PROCUREMENT SERVICES ADDENDUM

| Title: | Frazier Pediatric (KSCIRC) Fit-Out |
| Addendum No.: | Three (3) |

ADDENDUM NO. 3

① Louver Detail
3/4" = 1'-0"

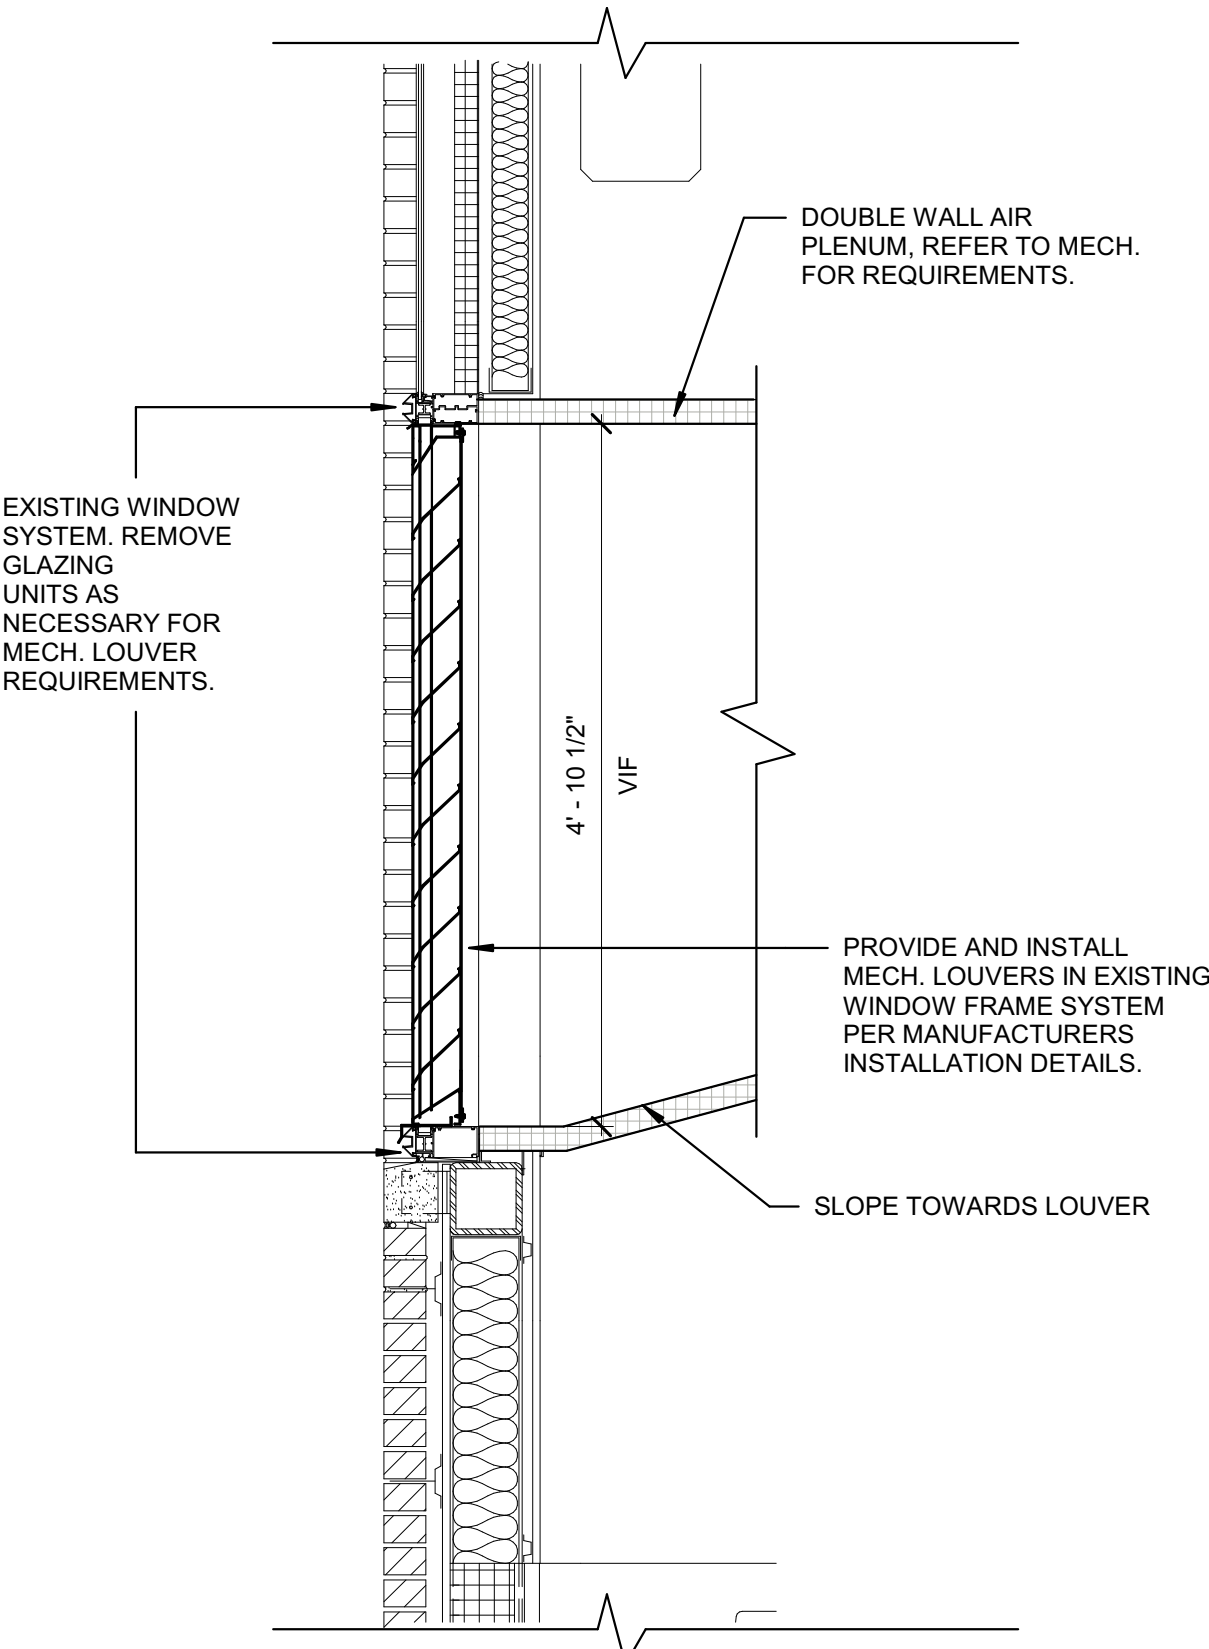
1. Please take a look at the attached screen shots from M501. We just noticed that the engineer wants (2) 144"x54" louvers in the 5th floor exterior wall. There's no mention of these louvers on the architectural or structural drawings. If I had to guess I'd say that these need to be installed in the window glazing frames, but there's no mention of that. We need the design team to let us know how these louvers are intended to be installed. **Install detail added in addendum, #3 drawings.**
